Product/Process Change Notice (PCN)

PCN #: PCN_ConCOM_20180301

Product Affected: ConUSB31_632723300011; 632723300021;
632723100011; 632723100021PCN Date: February 8th, 2018

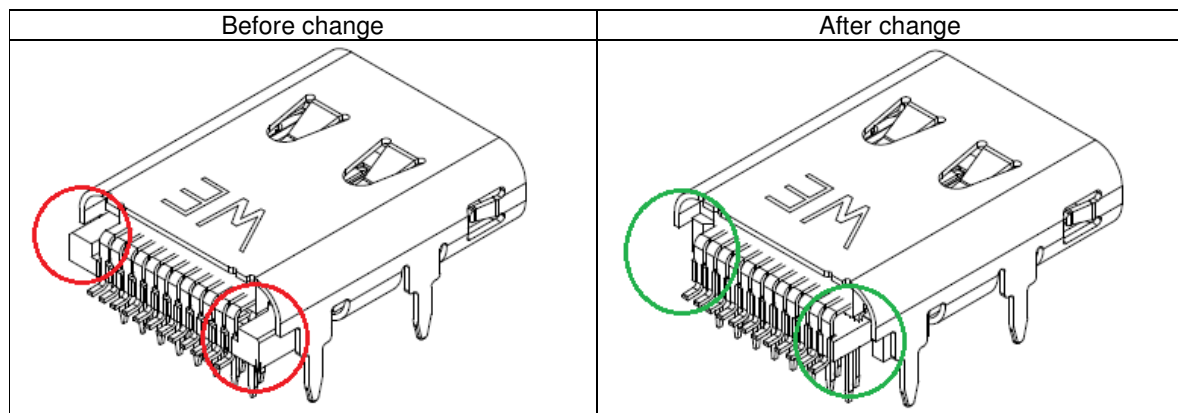
In order to enhance the product reliability, Würth Elektronik will change the housing design of these USB type C products and the manufacturing process.

This change has no impact on technical features (mating forces, insulation) of the product or connectors functional dimensions (layout, outer/overall dimensions).

Würth Elektronik reduces plastic housing size in order to facilitate mold extraction and improve processability.
